SSS-FSAR

QUESTION 211.1

SUSQUEHANNA STEAM ELECTRIC STATION
UNITS 1 AND 2
FINAL SAFETY ANALYSIS REPORT

FSAR FIGURE 211.70-1

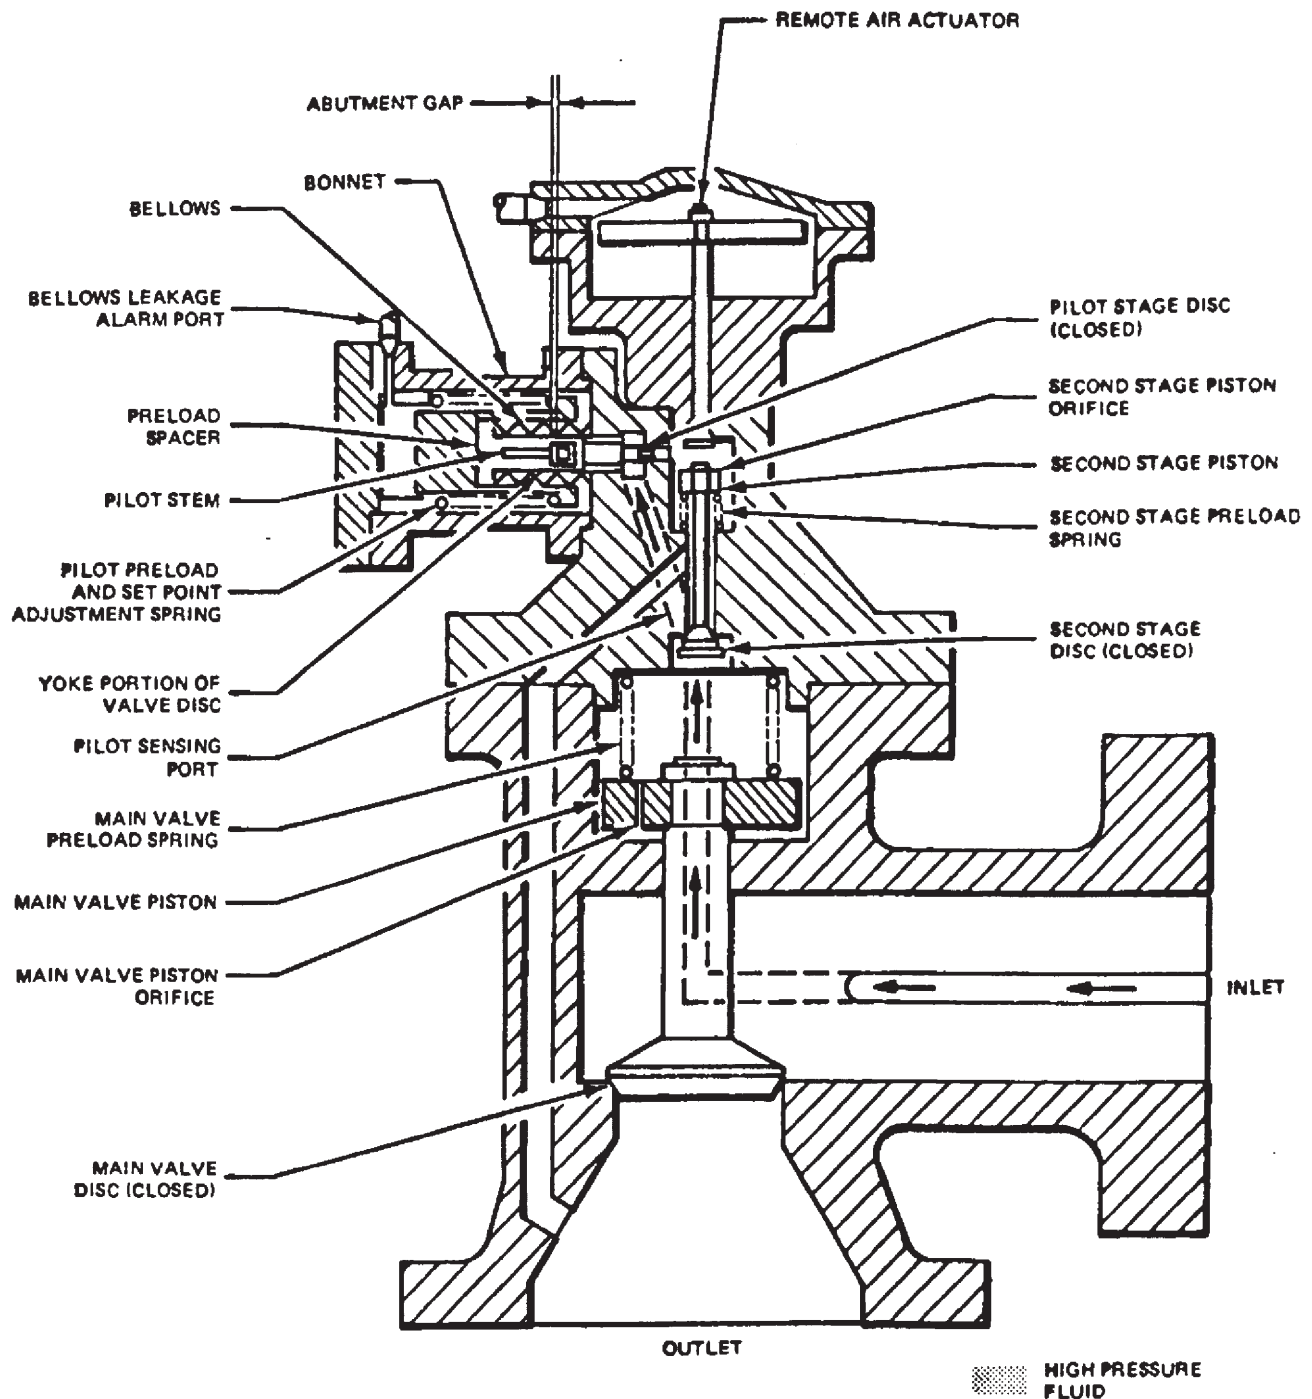
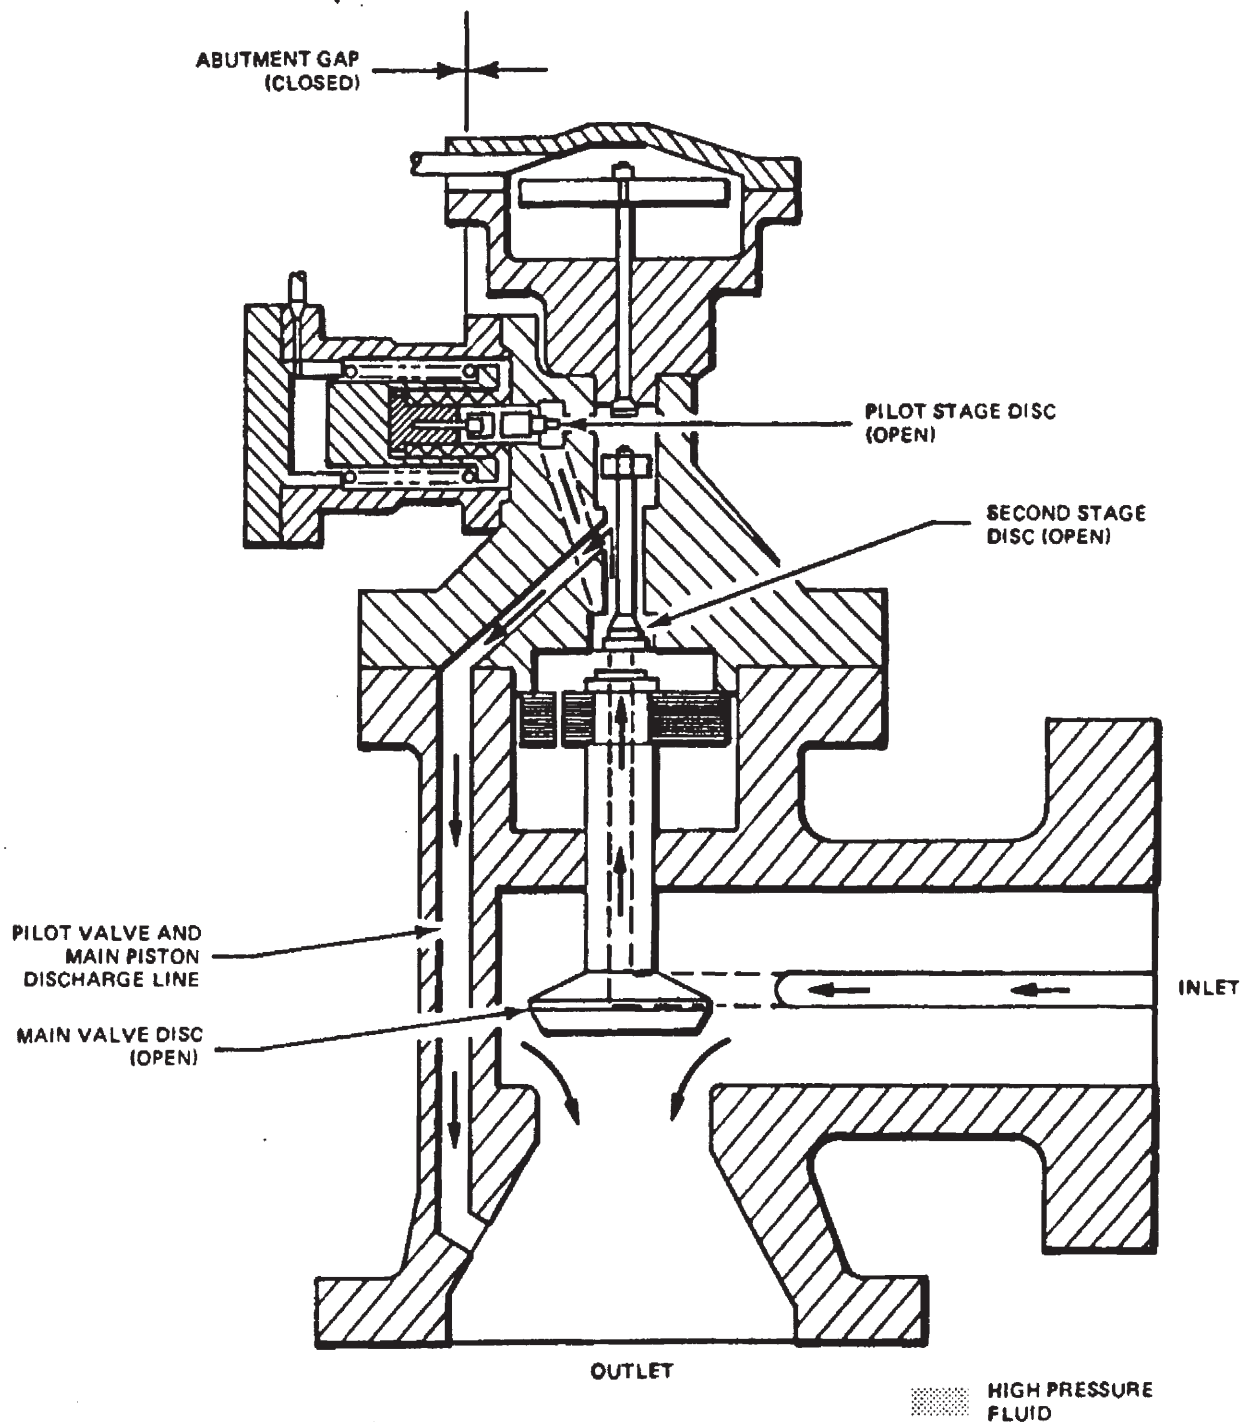
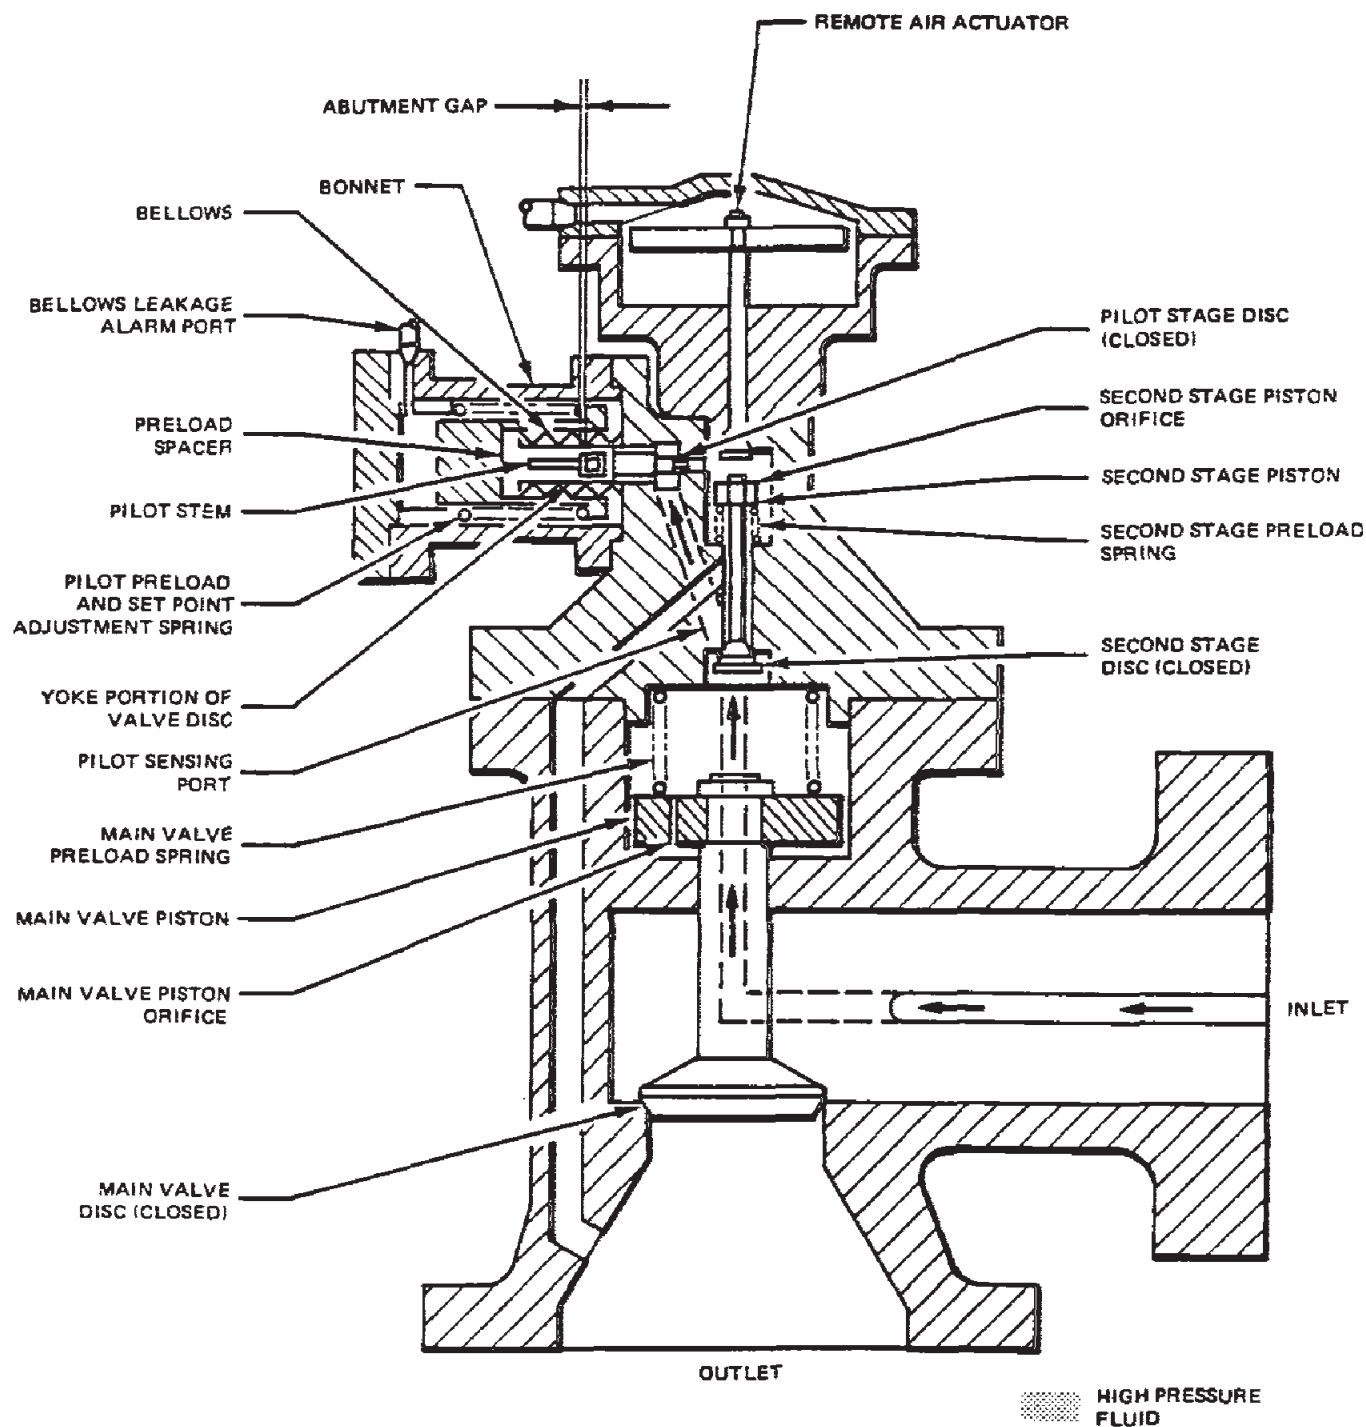
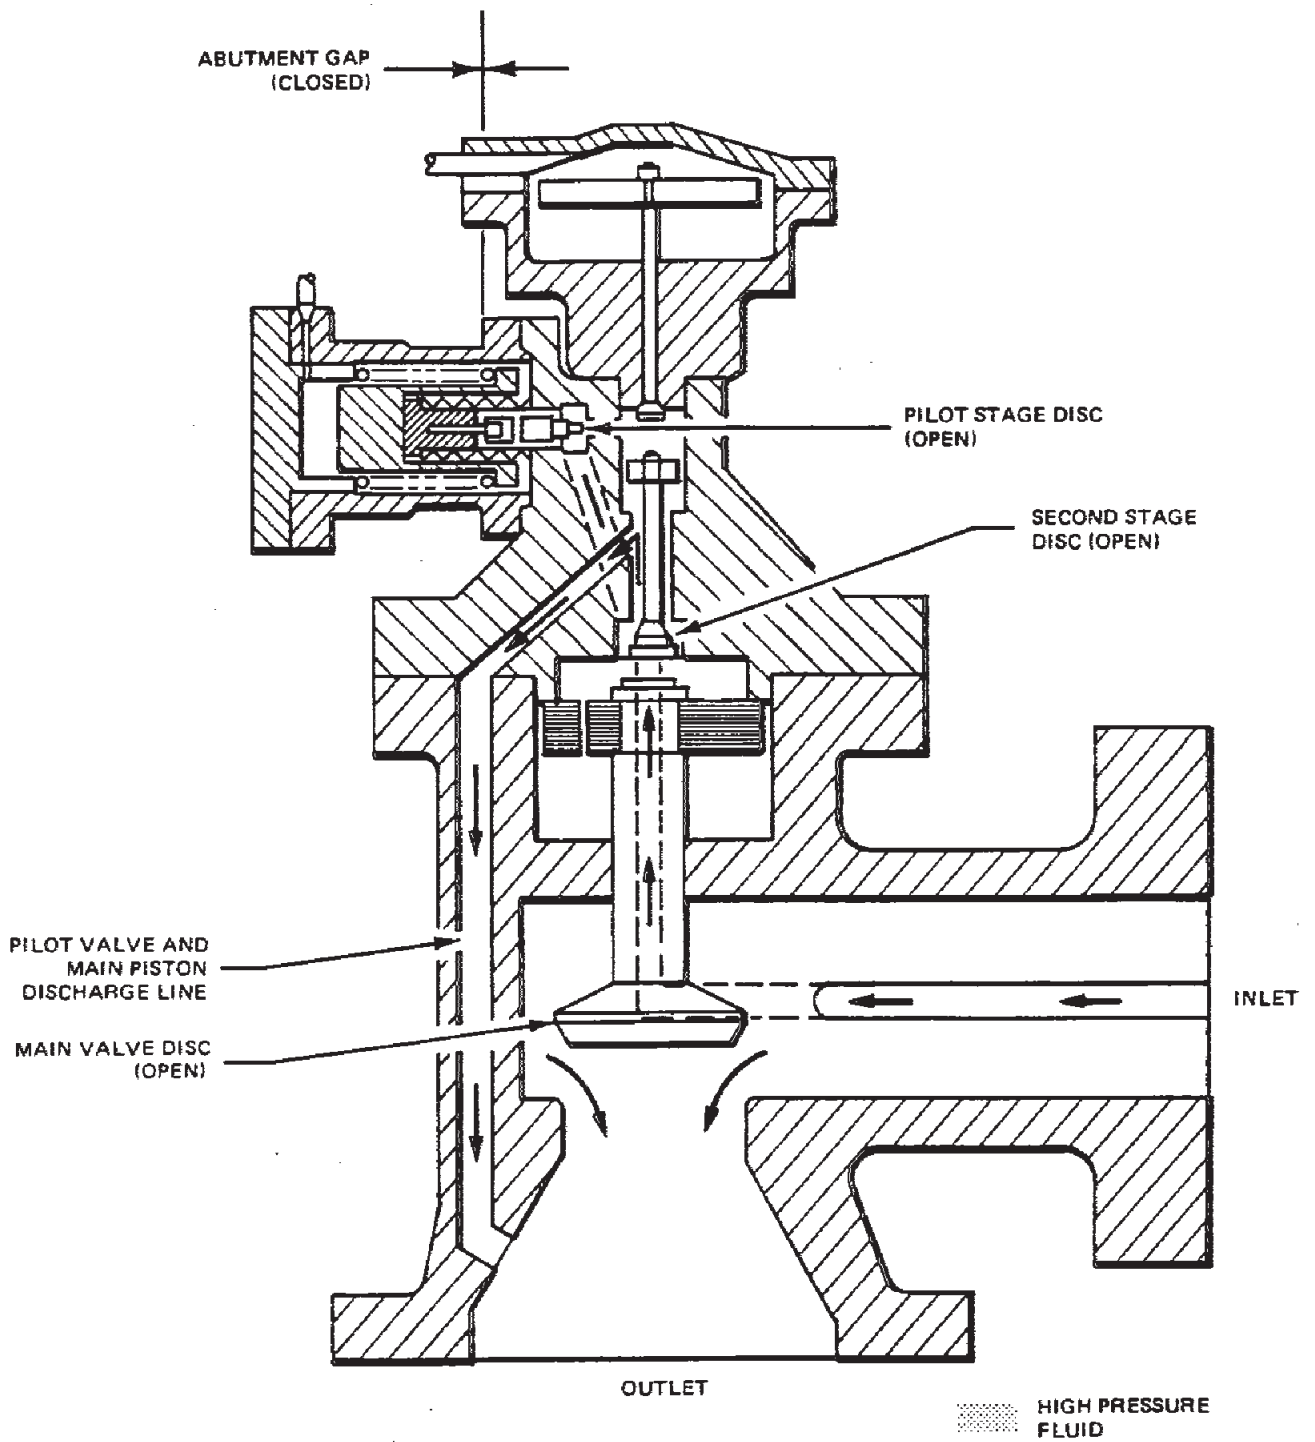
In 7.3.1.12.1.4.2, you state that a dual solenoid-operated pilot valve controls the pneumatic pressure applied to the "bellows actuator" which controls the safety/relief valve directly. In Figure 211.70-2, you show a cross-section of a Crosby valve which has a piston type pneumatic actuator. Also, in Table 211.70-1, you state that the SSES safety/relief valves have no pilot valves but in Section 7.3.1.1a.1.4.2, you state that the air accumulator is sized to provide air for five actuations of the pilot valve following a failure of the pneumatic supply. Resolve these discrepancies.

FIGURE 211.119-1, Rev 47

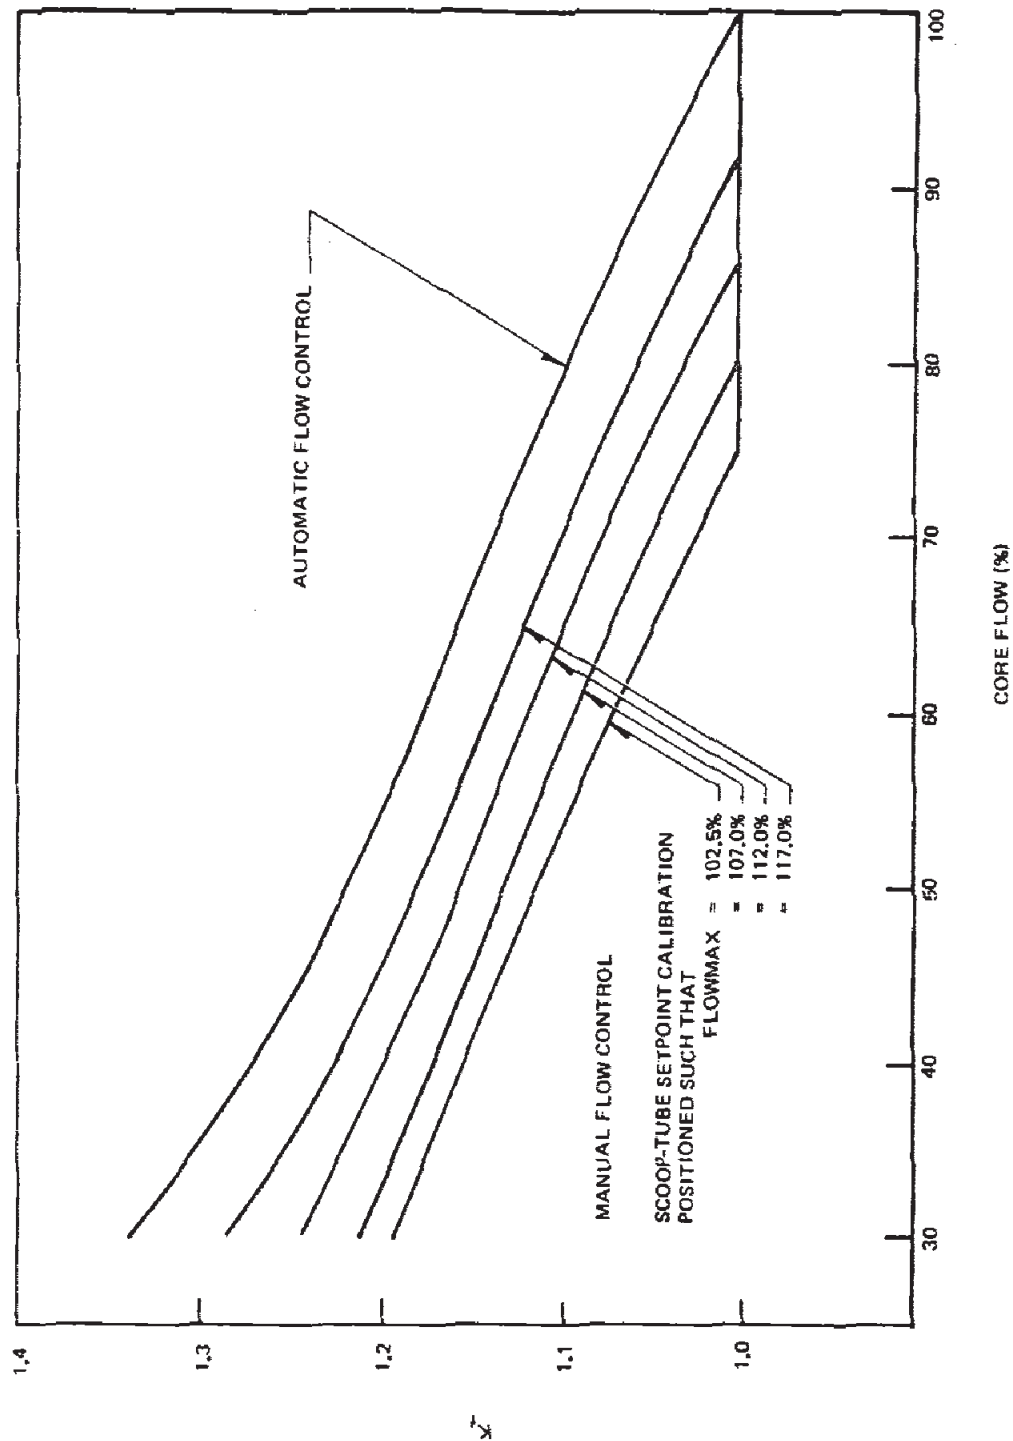
For the recirc flow control failure with increasing flow transient (Section 15.4.5) provide the initial operating MCPR determined at 65% NB rated power and 50% core flow. In addition, provide the K_f factors as a function of core flow for the automatic and manual flow control modes of operation. Furthermore, provide the maximum flow control set point calibration limit (e.g., 100% or 105% of rated flow) for the recirc loop flow control valves used in the transient analysis.

Provide recirculation pump M-G set points for the manual flow control mode assumed in the analysis. Also, you reference the GE topical report NEDO-10802 as the dynamic model to simulate this event. Since NEDO-10802 does not describe the complete event, discuss in greater detail the overall method used to calculate the CPR.

A plot of K_f factors versus core flow is shown on Figure 211.119-1. Note that the M-G set points for the manual flow control mode are shown on the figure; because flow control is provided by M-G sets there are no flow control valves and thus no flow control set points.
